The Town of Hilton Head Island
Design Review Board Regular Meeting
Tuesday, January 28, 2020 – 1:15 p.m.
Benjamin M. Racusin Council Chambers
AGENDA

Town of Hilton Head Island
Design Review Board
Tuesday, January 14, 2020 at 1:15 p.m.
Benjamin M. Racusin Council Chambers

MEETING MINUTES

SCALE FEET
 Scale: 1" = 10'
 Fourth Revision 12-4-19

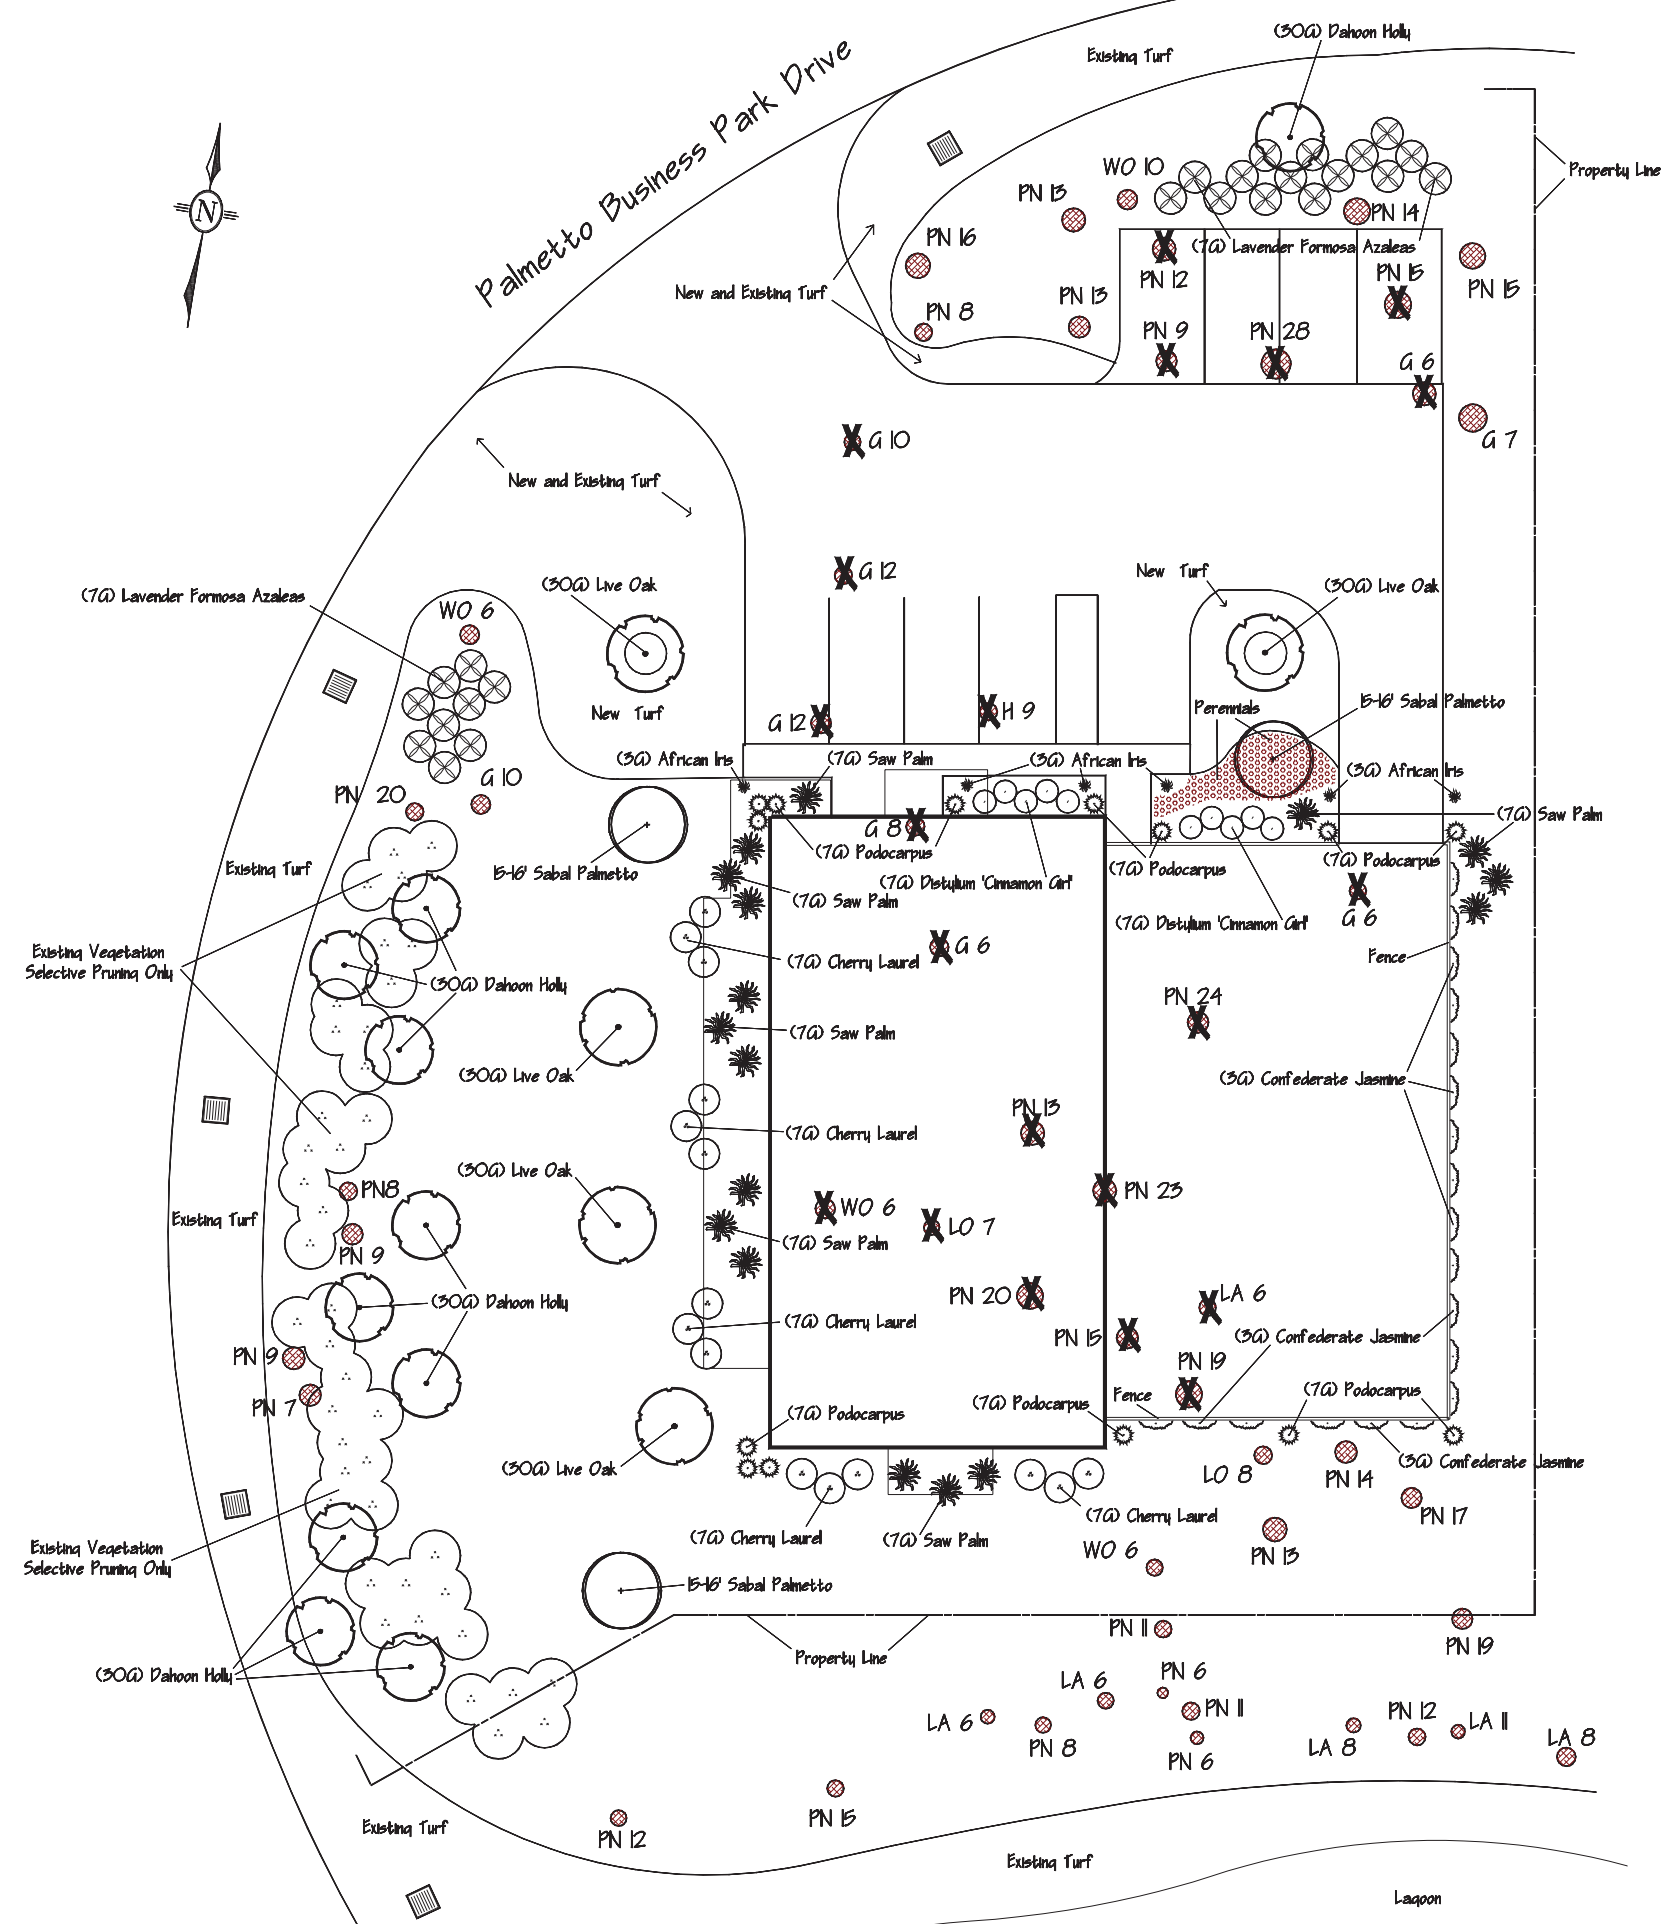
1. The DRB issued a Final Approval of this project in Nov. of 2018. The contractor cleared the understory buffer even after its preservation was made a condition of the DRB approval. The owner was required to submit a plan to replant the buffer to the DRB for approval.
2. ~~Delete the pot size specification (30 gal.) from the wax myrtle and yaupon holly specifications on the plant schedule emphasizing the 6' height and 4-3' spread specification needs to be met.~~

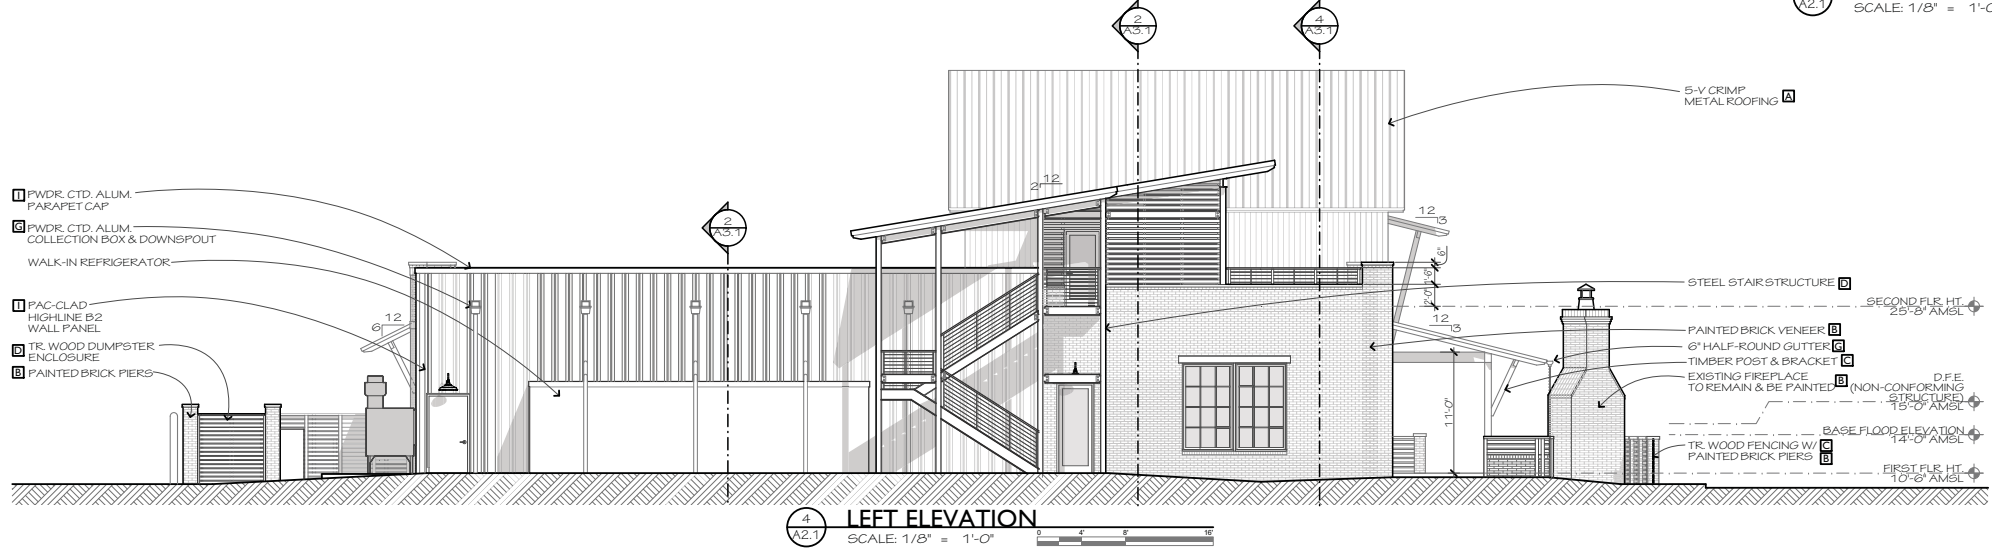
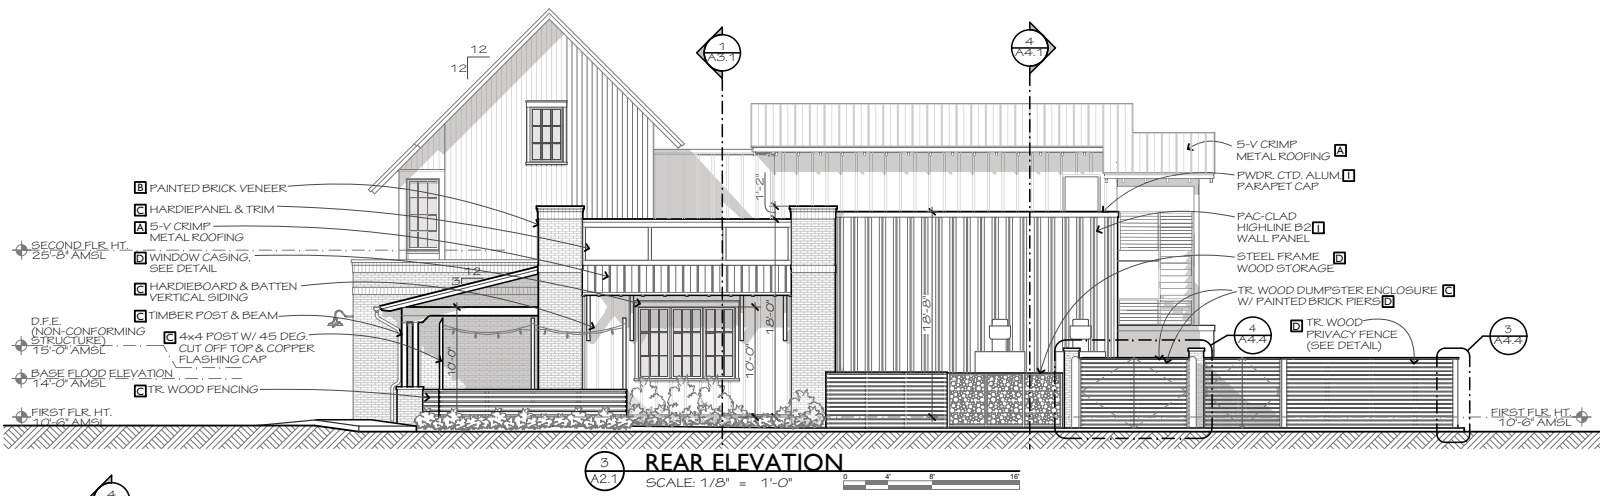
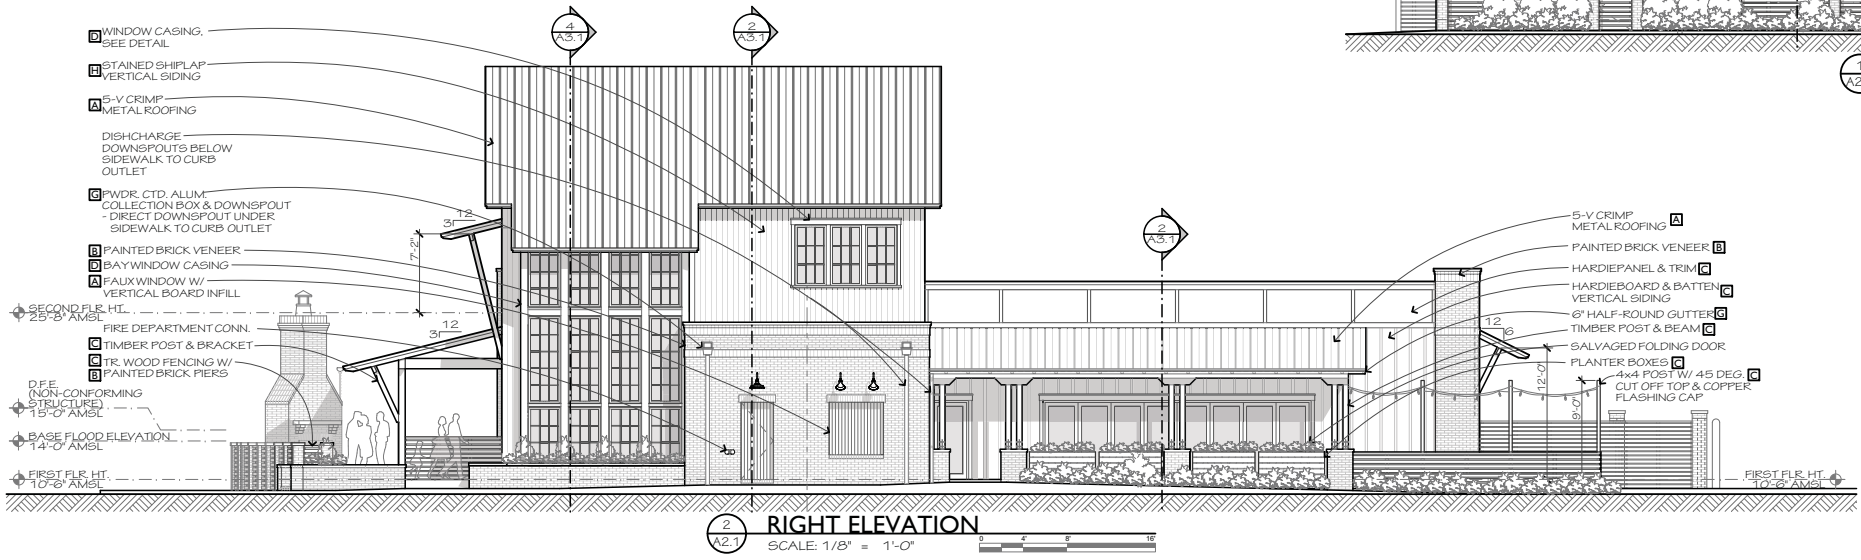
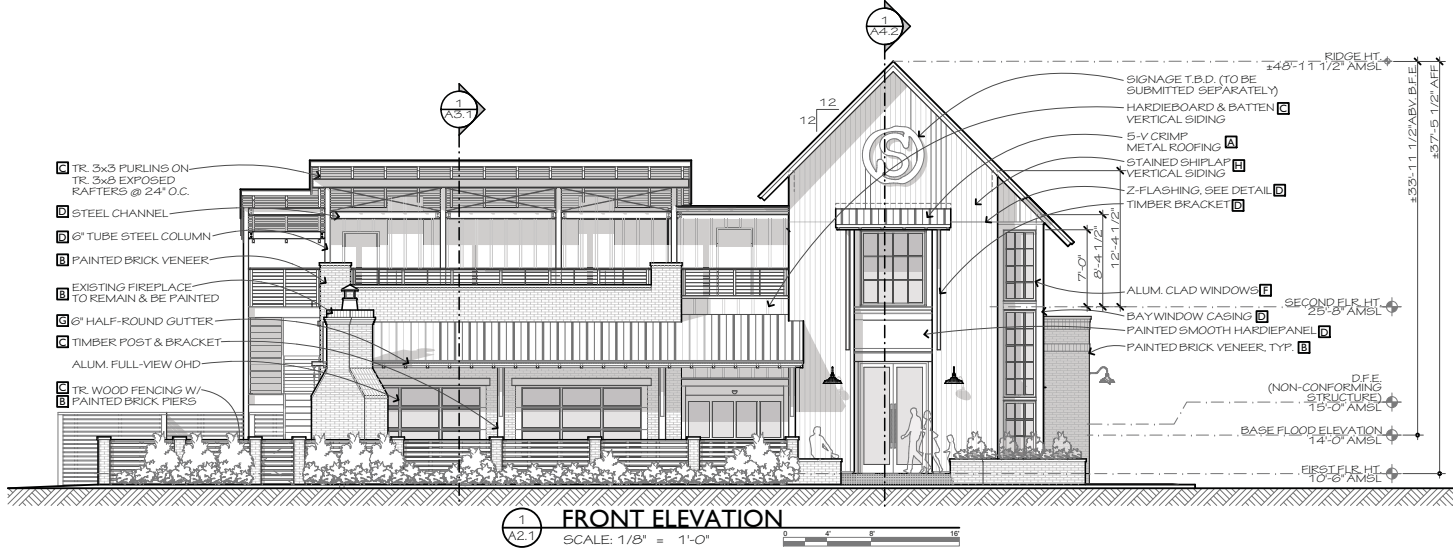
- Better reference the proposed colors on the elevations. It is unclear the color of the brick veneer.
 - A color schedule has been added to the elevation sheet (A2.1), and material notes have been tagged accordingly. The painted brick will be Polished Concrete SW 9167.

8 PLANTER BOX DETAIL
SCALE: 1" = 1'-0"

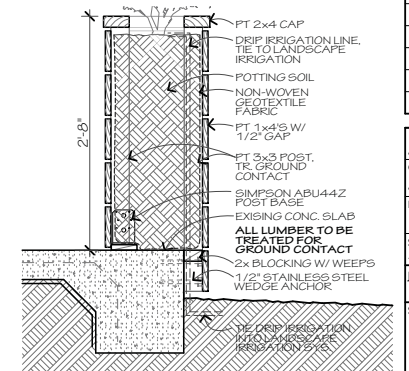
- A detail of the raised planter boxes has been added, see detail 8/A4.4. The planter will be built-in to the porch and drip irrigation will be supplied to the plantings. As part of the renovation project, we are using the existing slab dimensions for the porch.
